Cruach Clenamacrie

Further Environmental Information

Department: Development
Project: Cruach Clenamacrie Wind Farm

September 2025

7.8.2 Encroachment in Watercourse Buffers

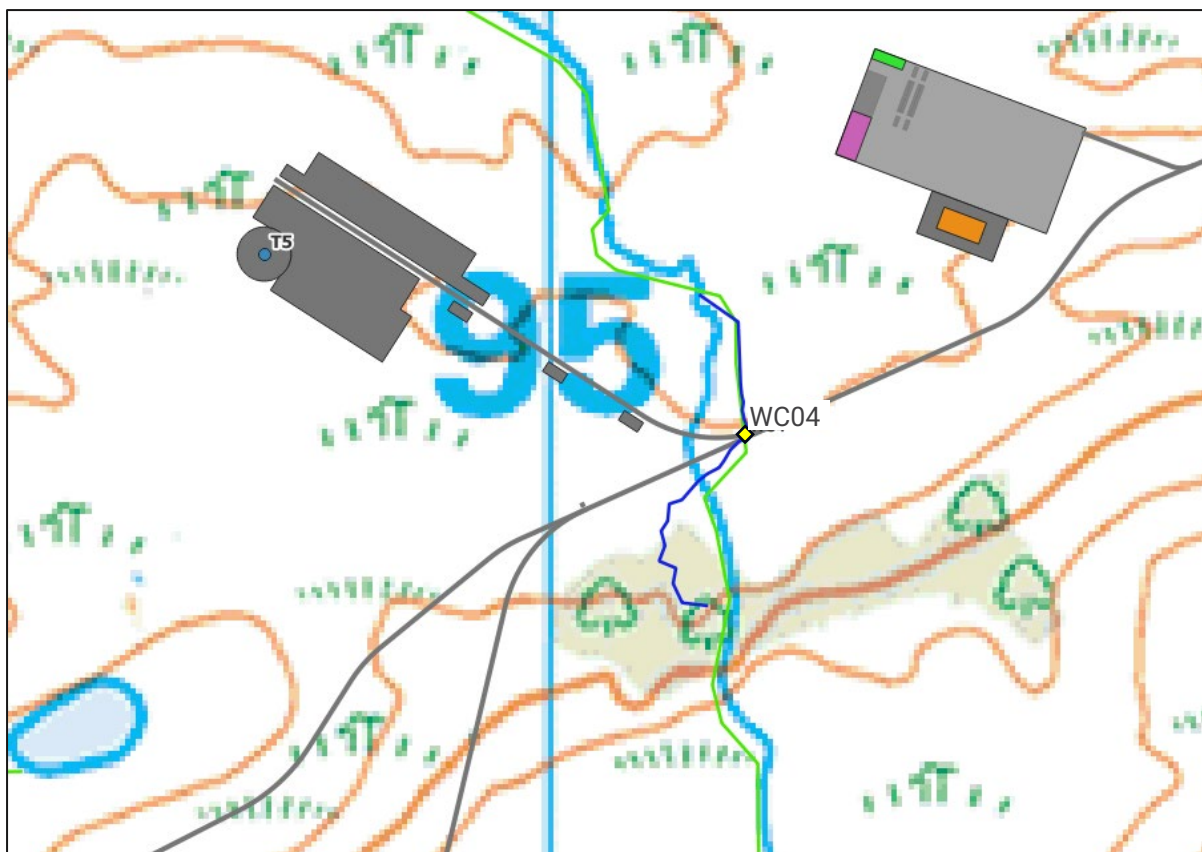
7.8.2.1 *'Several turbine locations and their associated hard standings appear to be encroaching into the 50m watercourse buffer...we request the applicant modifies the proposal in these locations to ensure and/or illustrates turbine locations have no deep excavations (greater than 1m) impinging on the 50m watercourse buffers.'*

7.8.2.2 Several amendments have been made to the proposed layout in order to reduce the amount of infrastructure located within the 50m watercourse buffers.
